Andhra Pradesh State Road Transport Corporation

CORRIGENDUM

TENDER NOTICE NO-APSRTC/C&B-01/2026-27-MED.

Name of the Tender: Request for Proposal for Procurement of 500 CNG Fully Built Buses Confirming to BS-VI (OBD-II norms) Emission Standards, CMVR and APMV Rules.

HAT
RACK

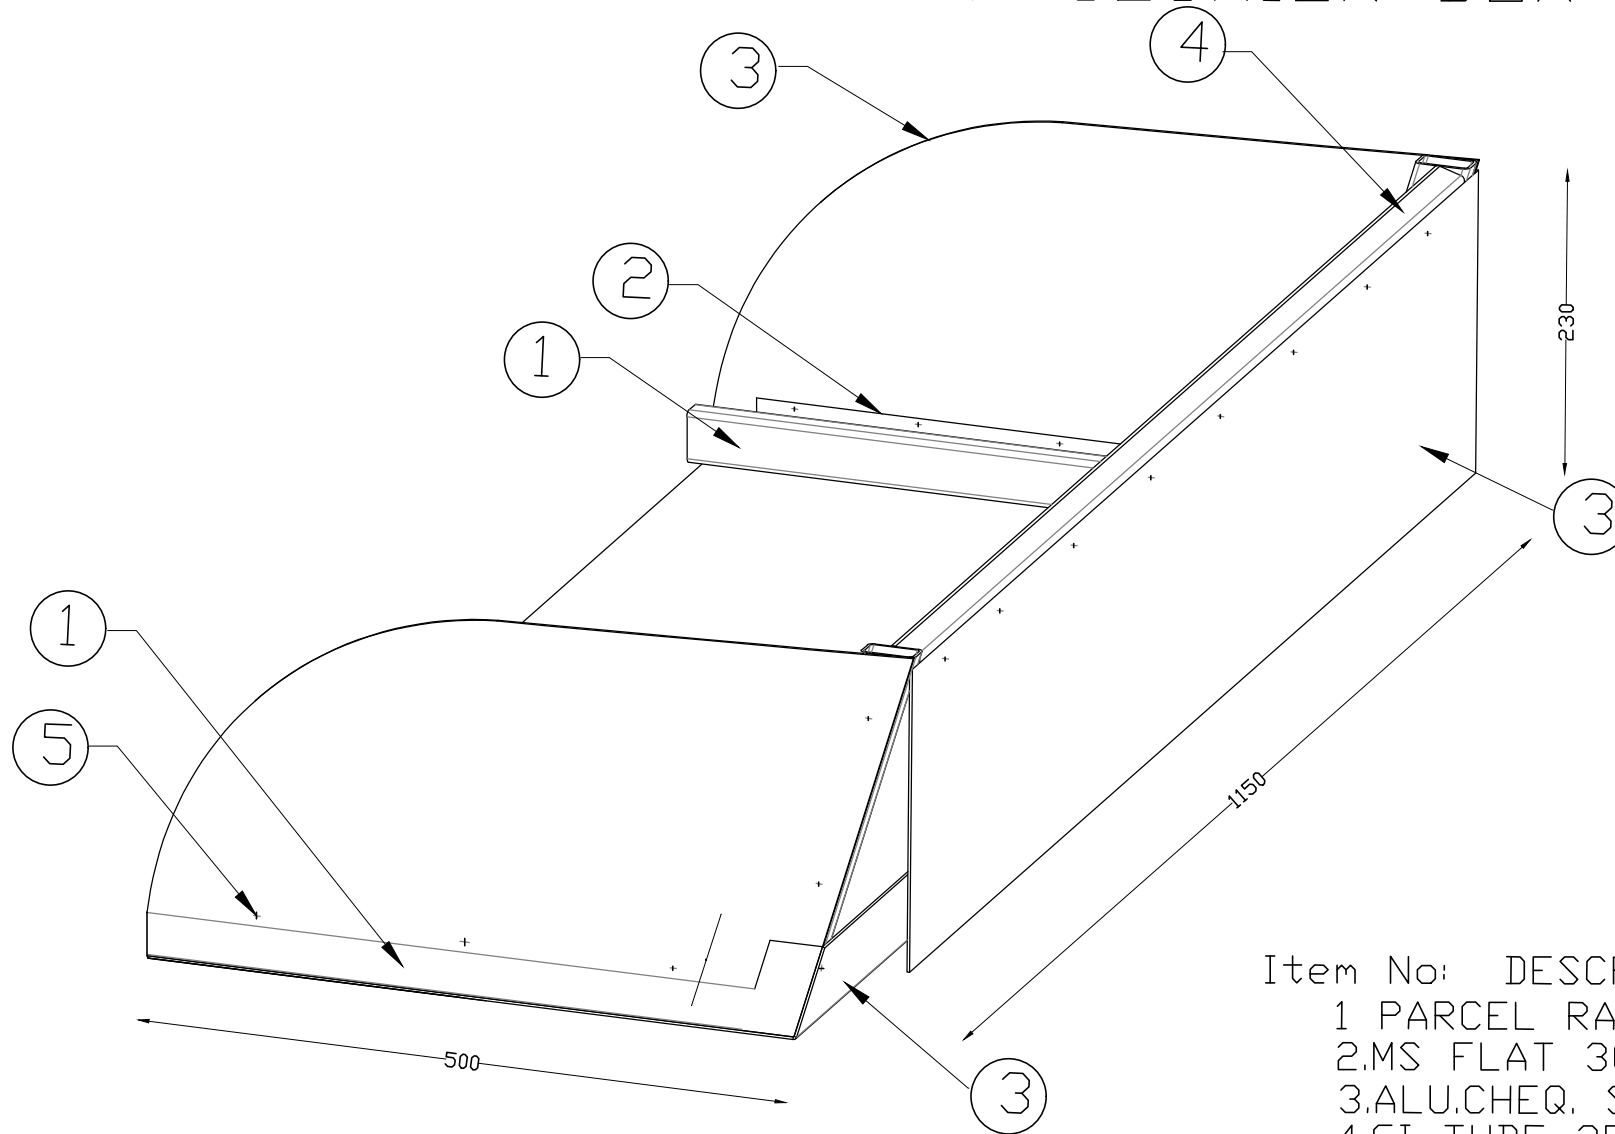
- Hat-rack photos to be provided in Ultra Deluxe buses are enclosed.
- Courier box photo and drawings, to be provided are enclosed.
- Bank Guarantee format for EMD amount is enclosed.

<u>Parcel Courier Box:</u> One Parcel Courier box to be provided at left side of parcel rack in 2nd pillar bay with suitable locking system.	TATA	-----	
			VECV	Sheetmetal box inside the hatrack will be provided. Kindly allow as per OE design	
36	S. No.- 37	<u>Stanchions:</u> Four stainless steel tube stanchions in 304 grade of 38 mm OD x 1.6mm thickness as per IS: 6913-1992 should be provided in the saloon as per seat layout plan.	AL	Steel pipe material as per IS 3607:2006 OR LATEST, Grade WT 160 of dia 32mm with anti-slip PVC sleeve of 2mm thick (Steel + PVC sleeve OD 36mm) or As per OEM Design	Stainless Steel is accepted. But size may be as per OEM design.
			TATA	-----	
			VECV	Ok for Stanchions - 4Nos. With Stainless Steel as per OE design - Diameter available is 32mm x 1.6mm thickness. Kindly allow as per OE design meeting CMVR & AIS norms	
37	S. No.- 38	<u>Roof Grab Rail:</u> Grab rails to be provided on LH & RH side of hat rack with 25mm X 1.6mm SS tube in alternate bays. Length of each grab rail is 1130 mm.	AL	Steel pipe material as per IS 3607:2006 or Latest, Grade WT 160 of dia 32mm with anti-slip PVC sleeve of 2mm thick (Steel + PVC sleeve OD 36mm) or As per OEM Design	Agreed as per OEM design & CMVR.

- The hat rack with brackets in GI rectangle tube 40x20x2 mm and GI formed 'Z' in 2 mm thick shall be provided. The interior width shall not be less than 460mm. Roof ceiling to hat rack clear opening shall be 240 mm
- The exterior of hat rack bottom shall be pasted with 0.7 mm PVC laminated GI sheet of approved shade. The interior of hat rack shall be provided with reinforcement of formed 'U' section of 1.6mm GI sheet with 20mm Thermocole insulation of FR grade and covered with 0.91 mm GI sheet and over laid by PVC coated GI sheet 0.7 mm thick.
- Hat rack edges are to be provided on both sides with Mercedes Benz type profile beading having LED strip and grab support at top area through out the length. Hat rack ends are to be closed and to be made soft duly providing with foam and fabric covering.

NOTE: a. TO BE PROVIDED IN LH SIDE PARCEL RACK (1st BAY)

b. FLAP DOOR IS TO BE FITTED WITH PIANO HINGE
AND LOCKING ARRANGEMENT
